Cottonex Fashions Limited

Plot No. 12 & 13, Kalurghat Heavy I/A, Mohora, Chandgaon, Chattogram-4208

19 October 2023

Observations

Table 3.1: Equivalent Crushing Strength of Concrete (Column)

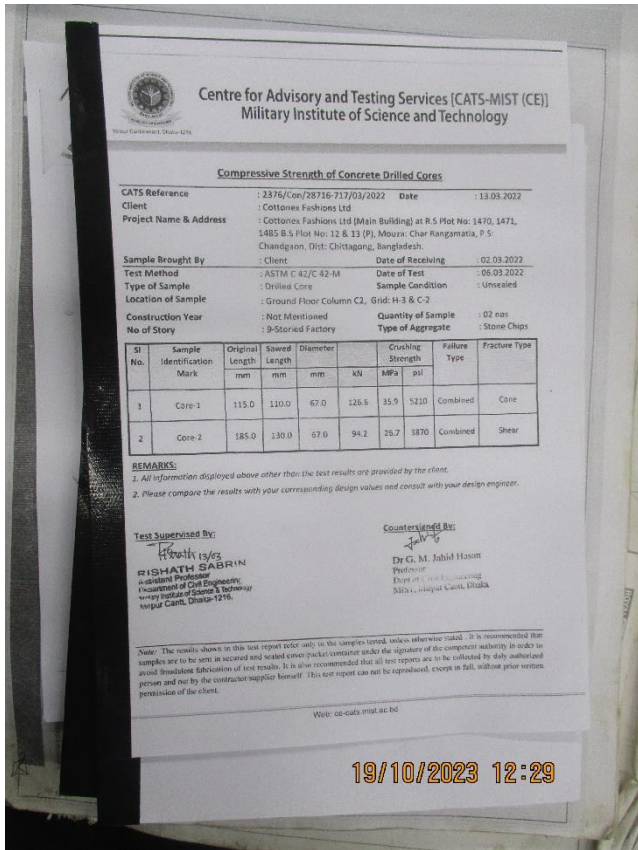
4-nos of concrete cores taken from column (5210psi, 3870psi, 5960psi & 5790psi); but two core value (5960psi & 5790psi) used in calculating the equivalent concrete strength.

Also, total 14 sets of cylinder test reports was available on site, but location was not mentioned in the reports.
